NUMBER
01141209

LINE	QUANTITY	UOP	CAT. NO.	ITEM NUMBER	UNIT PRICE	AMOUNT
ADDENDUM NO. 03						
THIS ADDENDUM HAS BEEN ISSUED TO MODIFY THE ORIGINAL SOLICITATION PER THE ATTACHED DOCUMENTATION.						
0001	1	EA		425-94		
	MODULAR FURNITURE					
***** THIS IS THE END OF RFQ 01141209 ***** TOTAL:

**SOLICITATION NUMBER:** 01141209  
**Addendum Number:** 3

Addendum #3

Exhibit A - 2nd floor

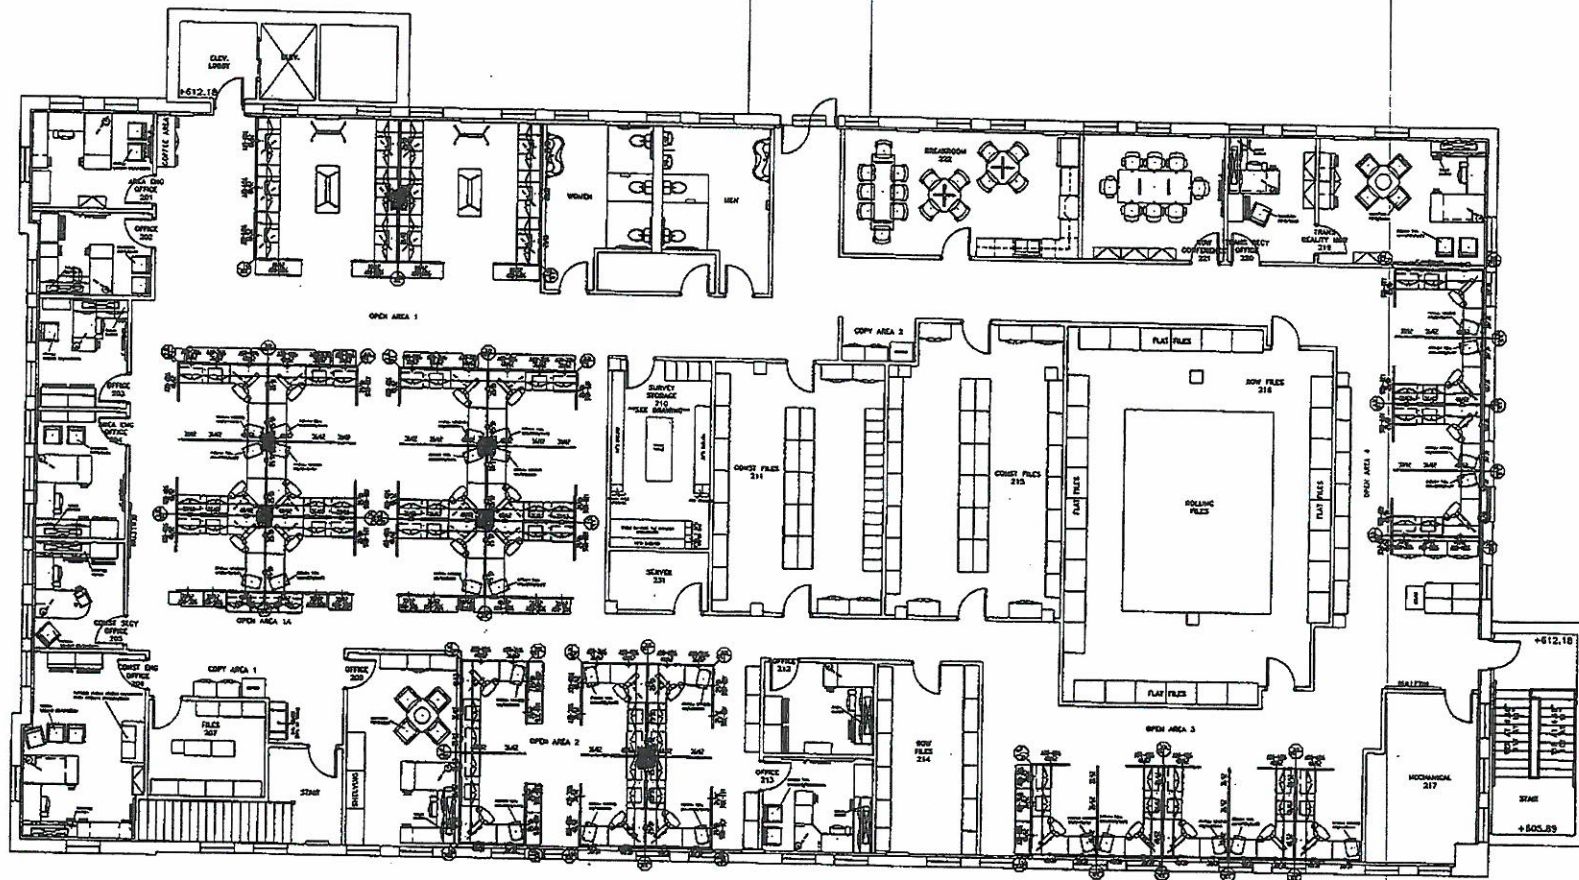
Power was mentioned that is was coming from the ceiling to the stations, locations of power poles are not noted in the drawing. That can change how connections are made. (Some of the stations could be powered by a whip from the wall.) Please advise.

We have included drawings of the power drops. Not all workstations have power coming from the ceilings.
